JOB TITLE:  
PROPOSED ENGINEERING WORKS  
96 BEACH HAVEN ROAD & 13 CRESTA AVENUE  
BEACH HAVEN

Drawing MS900 Detailing the proposed Secondary Stormwater Drainage

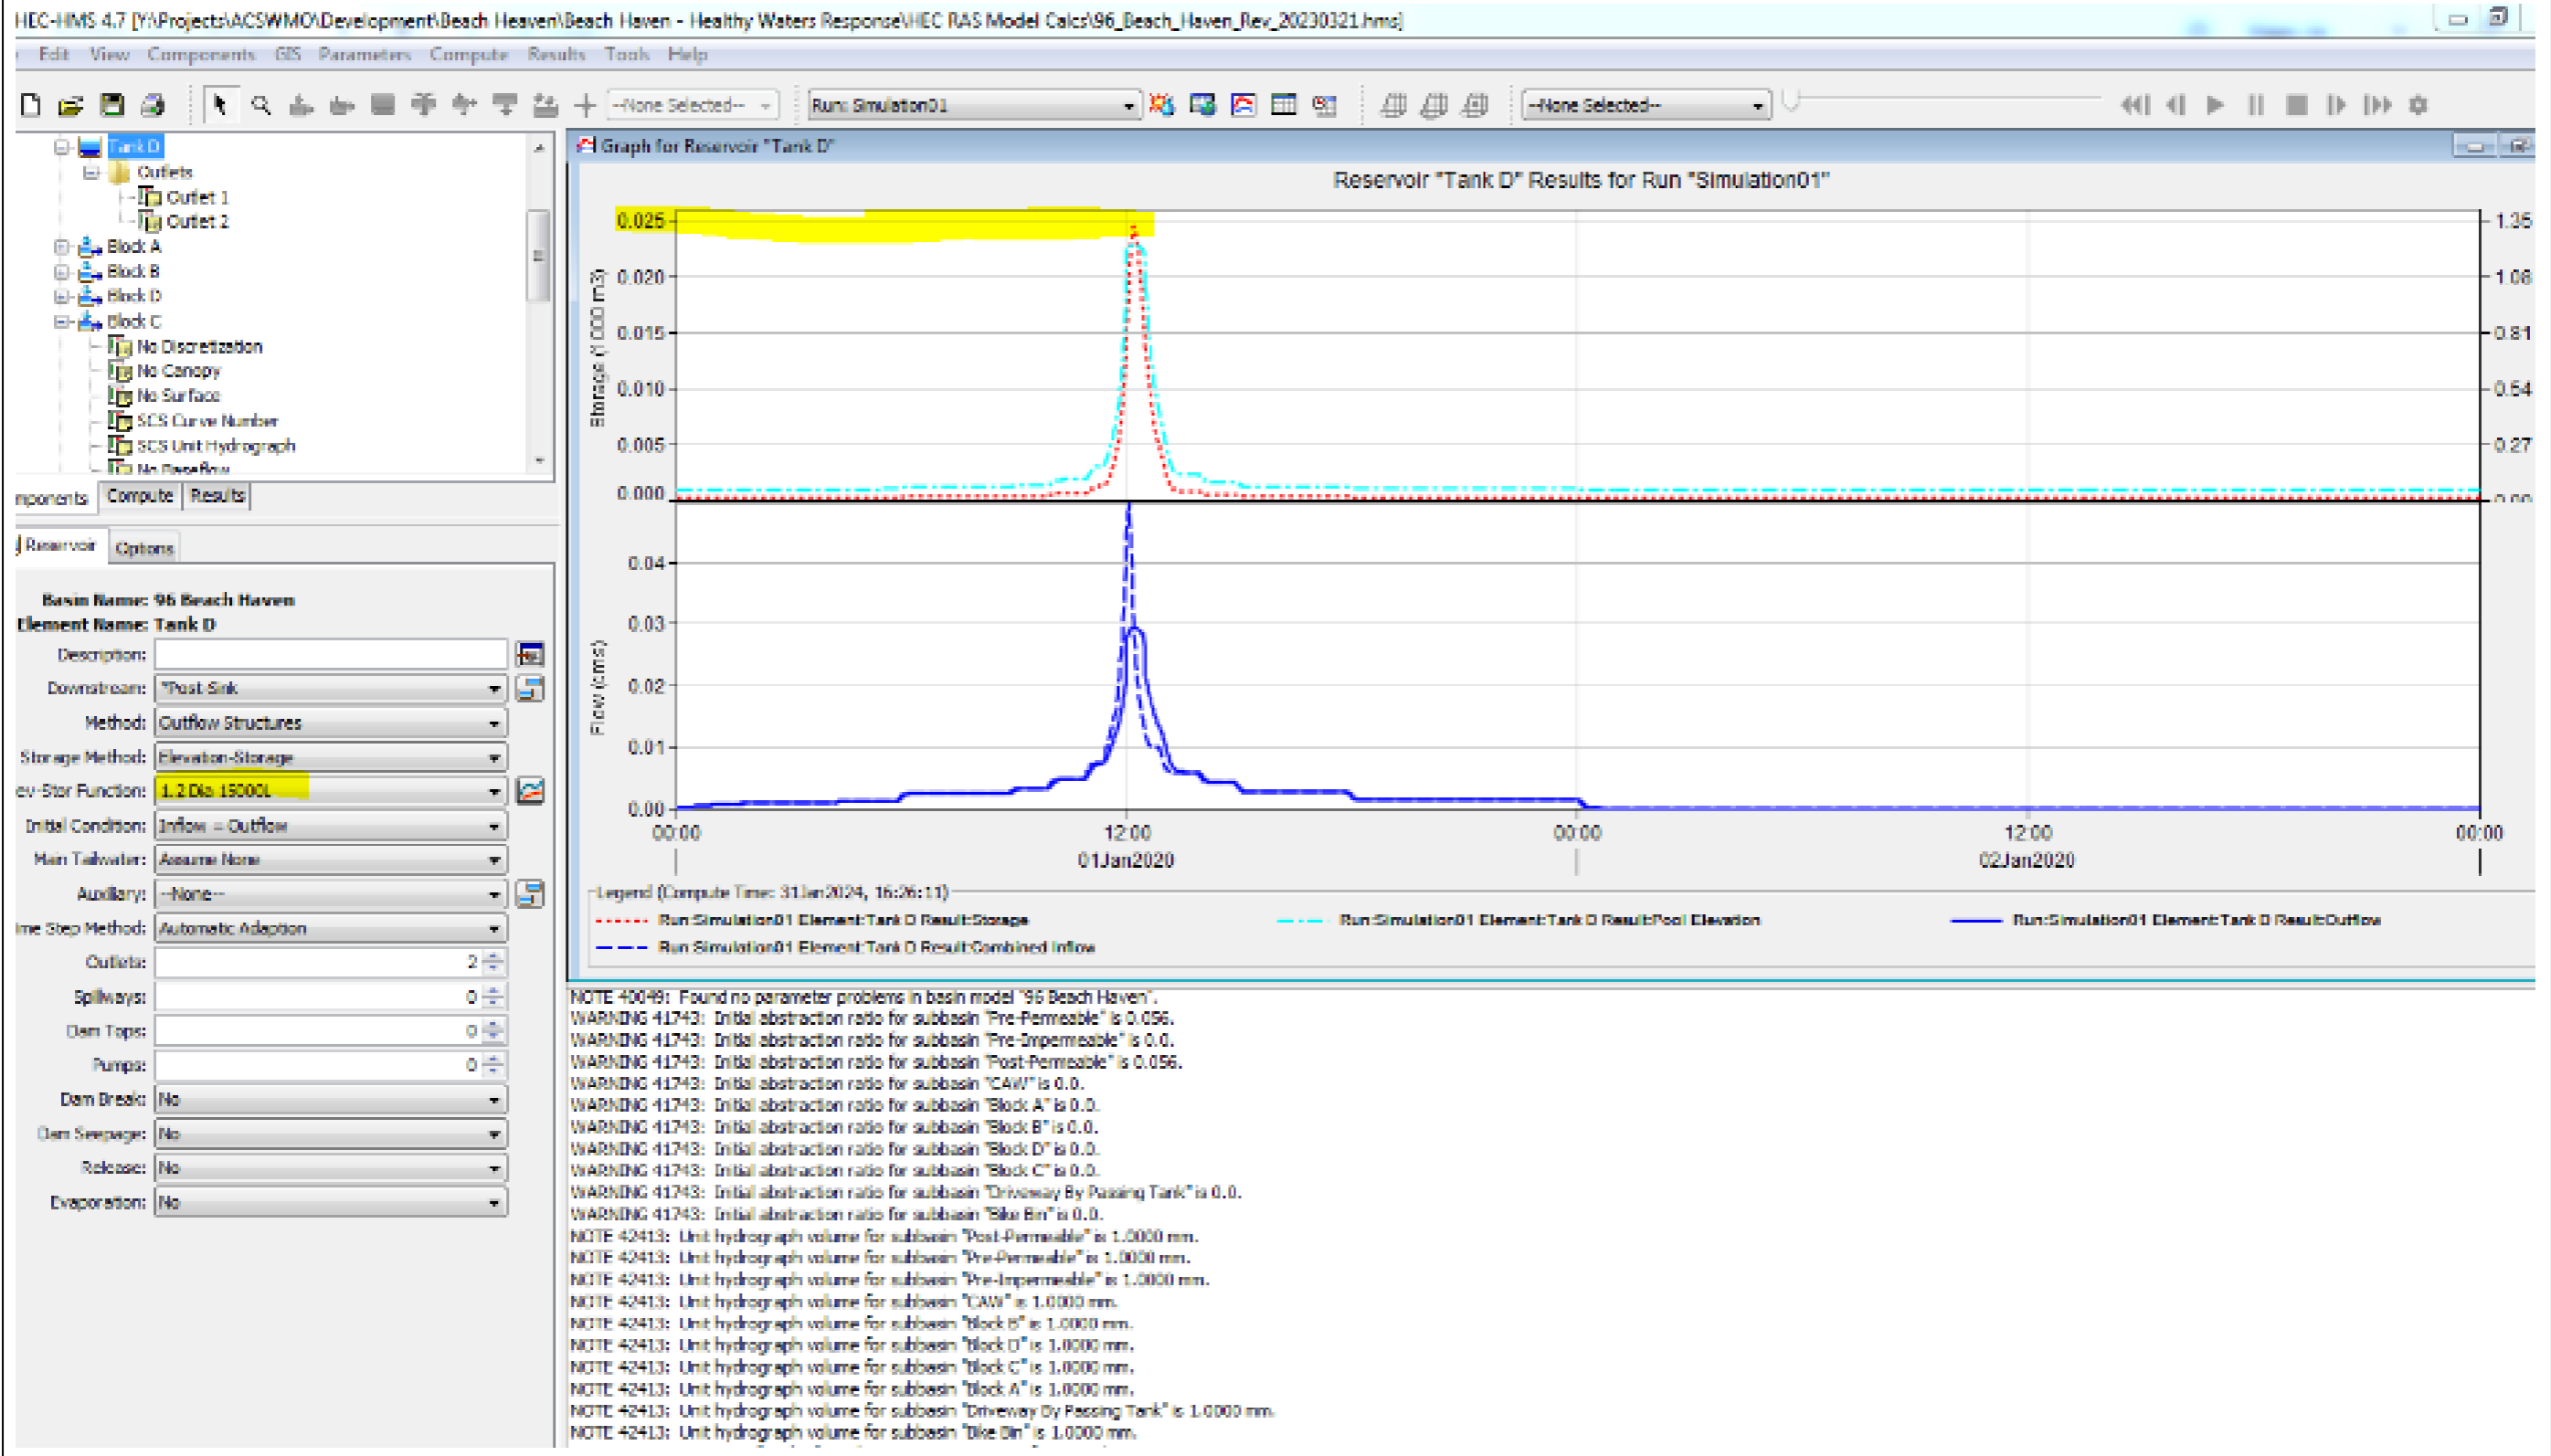
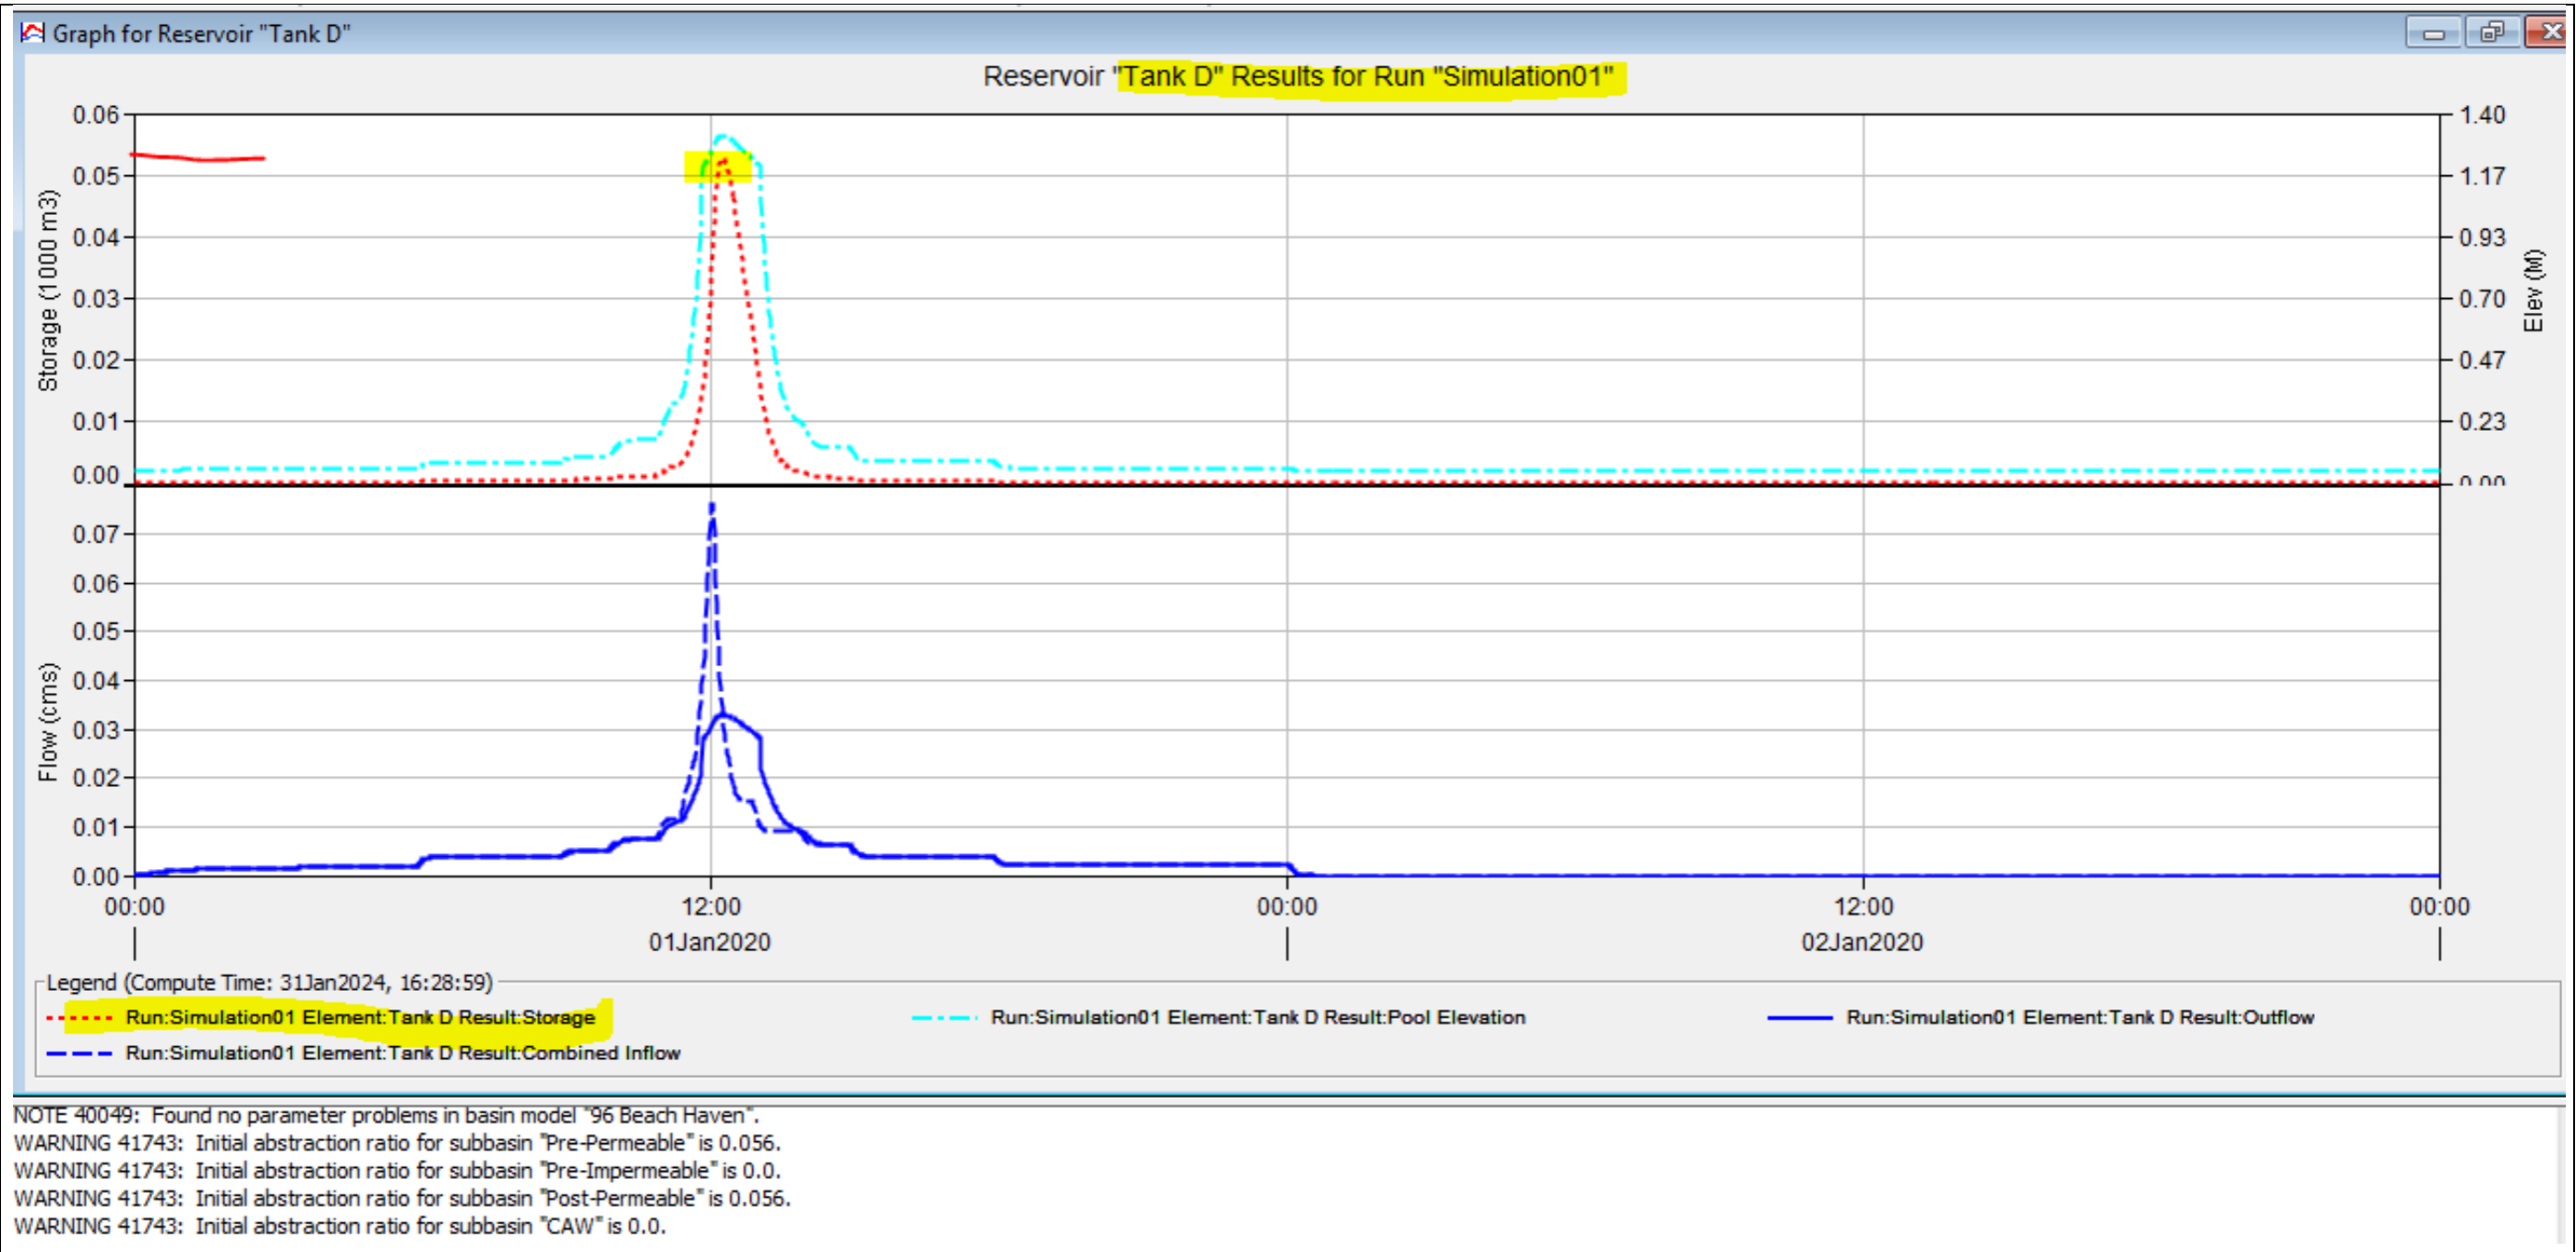
<b>HW2</b>	SW General	Please provide a concept drawing or plan showing the proposed layout of the stormwater drainage system, including the primary and secondary systems.	To enable the local authority to better understand—the nature of the request in respect of the effect it will have on the environment; the ways in which any adverse effects may be mitigated; the benefits and costs, the efficiency and effectiveness, and any possible alternatives to the request; appropriate to the scale and significance of the actual or potential environmental effects anticipated from the implementation of the change or plan.  This information is required so that the proposed stormwater management can be clearly understood. No layout plan was included in the SMP.	Please see attached Drawing RC400 detailing the proposed Primary Stormwater Drainage system. Please see attached Drawing MS900 detailing the proposed Secondary Stormwater Drainage system through the subject Site.	Acknowledge the provision of these two drawings outlining the proposed primary drainage system, and the existing secondary system indicating the area of the site that currently discharges to the OLFP and the additional area (1650m <sup>2</sup> ) to be diverted to discharge to the OLFP as opposed to the open watercourse.  Both drawings don't extend to any areas beyond the site boundaries and cover the full OLFP catchment upstream and downstream of the site. The secondary

We have previously seen layout plans as part of the SMP submitted with the Resource Consent application. However, we cannot assume that the layout of the proposed stormwater system has not changed from those seen previously.		system drawing also doesn't detail proposed contours and hence OLFP routes and directions and entry points of flows to downstream properties.
<b>HW3</b>	SW General	<p>Is stormwater runoff from the total development area proposed to be directed to the 750mm/400mm diameter stormwater pipe downstream and the overland flow path along the drain?</p> <p>Has there been any consideration of discharging some flows to the stream. The overland flowpath catchment plan in Appendix C of the SMP indicates some catchment draining to the existing overland flowpath. It is not clear what is proposed for that part of the site that currently drains to the stream.</p>	<p>To enable the local authority to better understand—the nature of the request in respect of the effect it will have on the environment; the ways in which any adverse effects may be mitigated; the benefits and costs, the efficiency and effectiveness, and any possible alternatives to the request; appropriate to the scale and significance of the actual or potential environmental effects anticipated from the implementation of the change or plan.</p> <p>There is a catchment divide within the site, with the natural drainage pattern appearing to be 40% draining to the natural stream channel to the north and 60% to the overland flow path to the west (refer to figure below).</p> <p>More information is required to before a full assessment of stormwater runoff effects can be completed.</p> 	<p>Please refer to attached drawing RC400 detailing the primary stormwater drainage system. All impervious areas are currently directed to the Detention Tanks, which in turn discharge to the existing 750/400mm stormwater line.</p> <p>Please refer to Drawings MS900 detailing the catchment areas of the Secondary System. Approximately 23% (1650m<sup>2</sup>) of the original site area drains to the eastern overland flow path (stream). The remaining 77% (5407m<sup>2</sup>) naturally drains to the western overland flow path through 15 Cresta Avenue to the north. Our proposal will retain approximately 14.5% of the original eastern catchment draining to the east (stream). The remainder of the eastern catchment will be diverted to the western catchment under the current proposal. This is due to the site primarily naturally sloping toward the West.</p> <p>As stated above, a small portion of the eastern catchment is retained, however the majority will now drain to the western overland flow path found entirely within the site boundaries. There is no defined overland flow path from the site boundaries to the eastern overland flow path (stream).</p> <p>Auckland Council policy typically requires the defined overland flowpaths to remain with the entry and exit points remaining as predevelopment. This is what we have adopted in our design.</p> <p>In short we have considered the overland flow paths and consider that sending more water to the east is more problematic and has more significant issues, than working with the existing defined overland flow paths.</p>
